Re: 12 Maple Avenue

Subject: Proposed Restaurant Redevelopment
12 Maple Avenue, Armonk, NY
Response to H&H Review Comments

The following additional information, clarification and updates are provided in response to comments received from the Planning Board at their meeting of February 12, 2024.

20 Maple Valet Parking 30 Cars

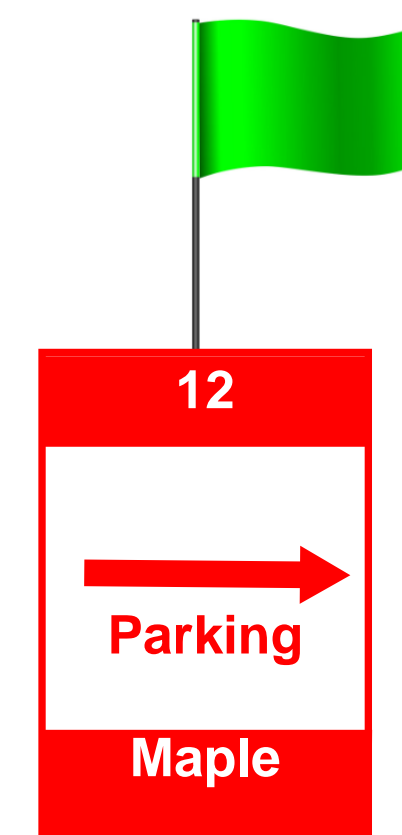
- There will be no shuttling of vehicles back and forth between the lots as valet parking is no longer proposed at 12 Maple Avenue.
- The maximum number of vehicles proposed to be parked at 20 Maple Avenue under valet operations has been reduced from 32 to 30;
- The revised plan provides more room for valets to interact with arriving and departing guests.
- The revised plan allows all vehicles parked at 20 Maple Avenue to be retrieved by having to move no more than 2 vehicles (25 vehicles will not require any vehicles to be moved, 1 will require 1 vehicle to be moved and 4 will require 2 vehicles to be moved).

(lot at 26 spaces, plenty of room to take 4 more vehicles - 15% - at the same time)

20 Maple Valet Parking 30 Cars

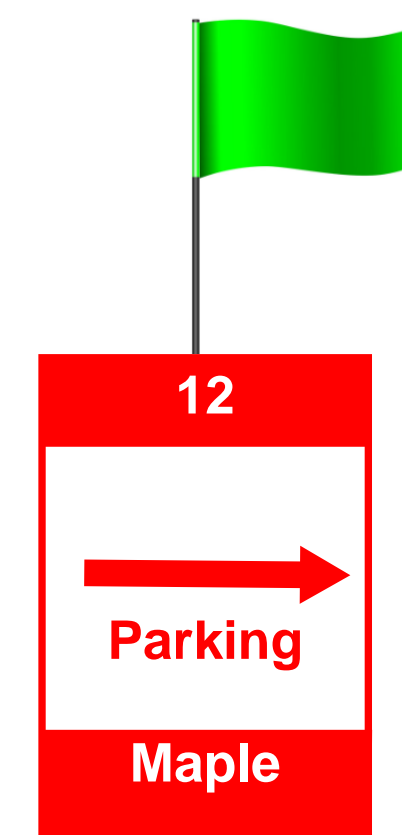
No vehicles have to be moved to retrieve the cars parked in the front of 20 Maple Avenue.

20 Maple Valet Parking 30 Cars

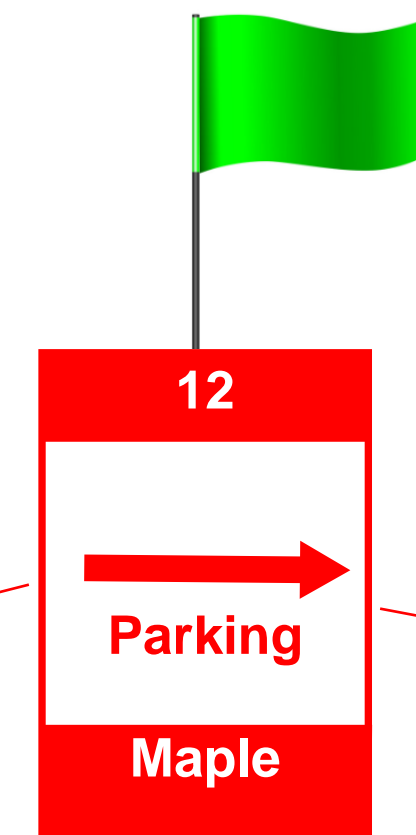
No more than
2 vehicles
have to be
moved to
retrieve all
vehicles

20 Maple Valet Parking 30 Cars

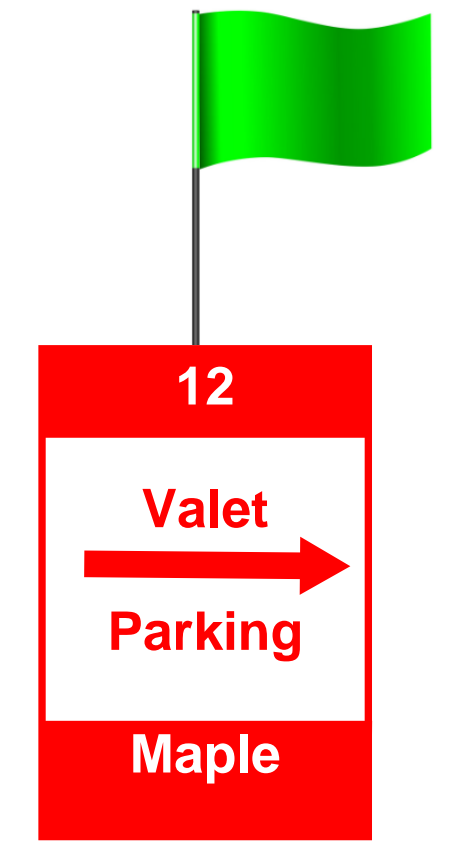
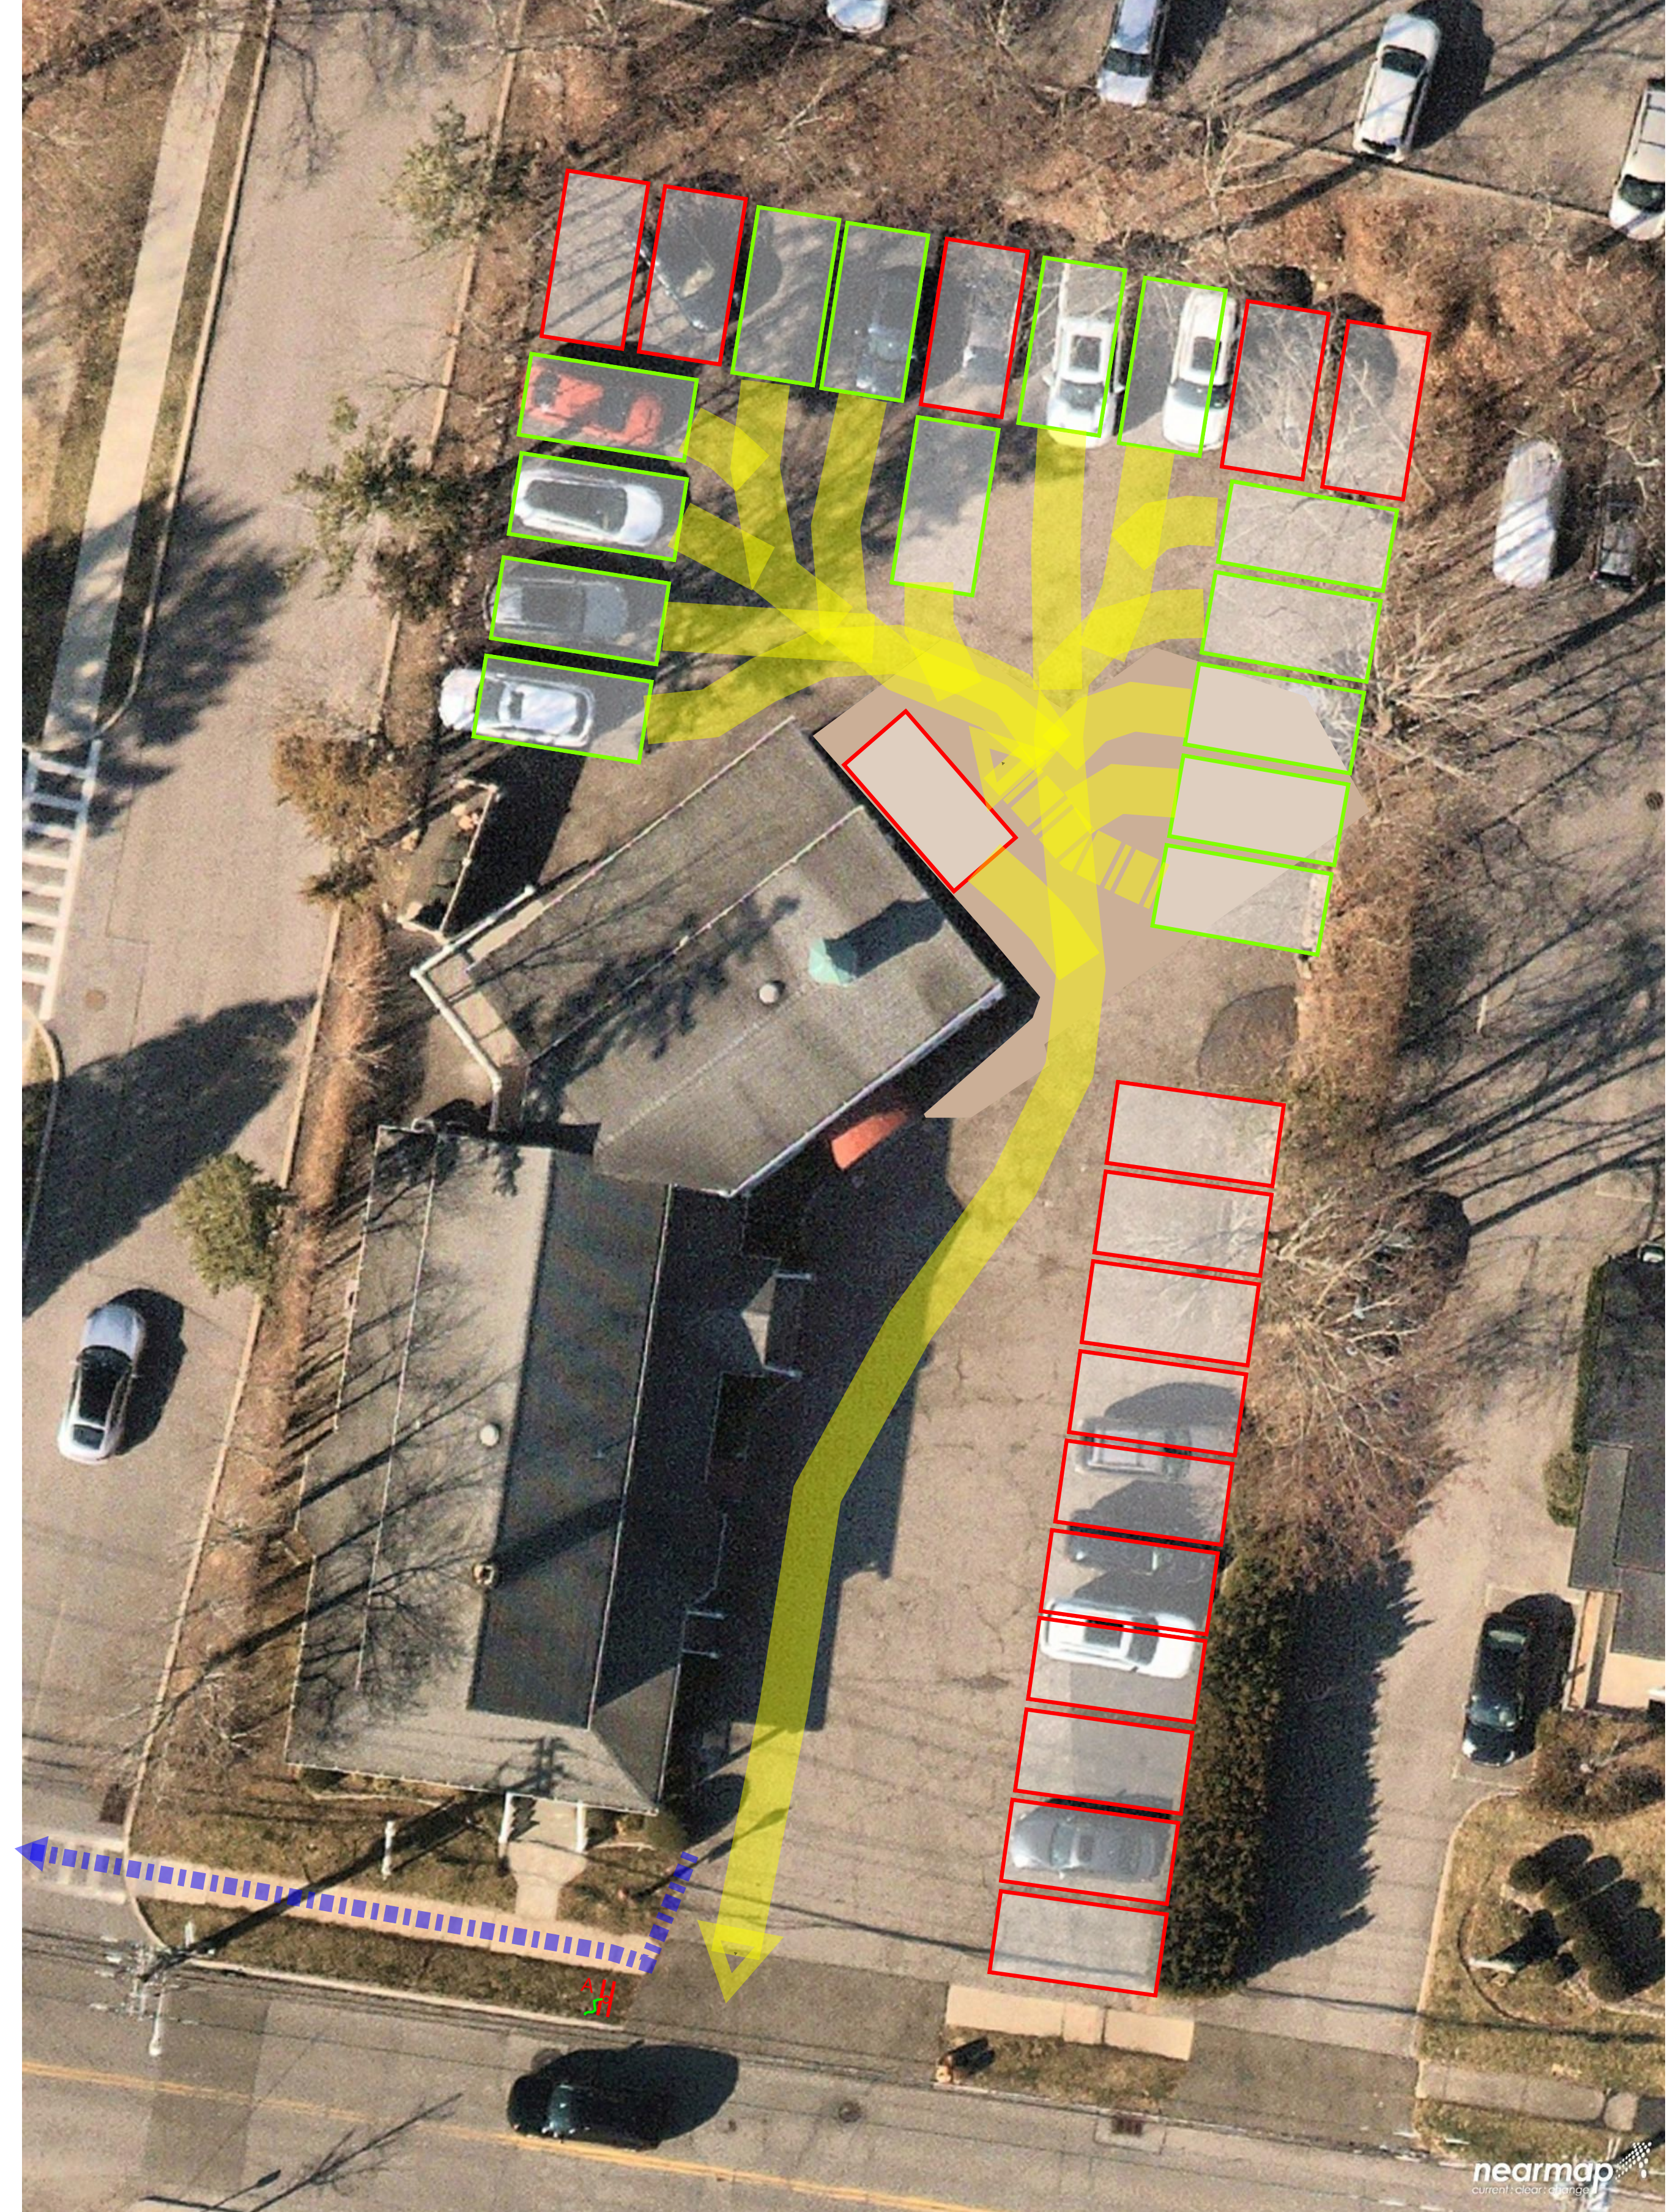
Only 1 vehicle has to be moved to retrieve the North Middle vehicle. No vehicles have to be moved to retrieve the remaining back vehicles.
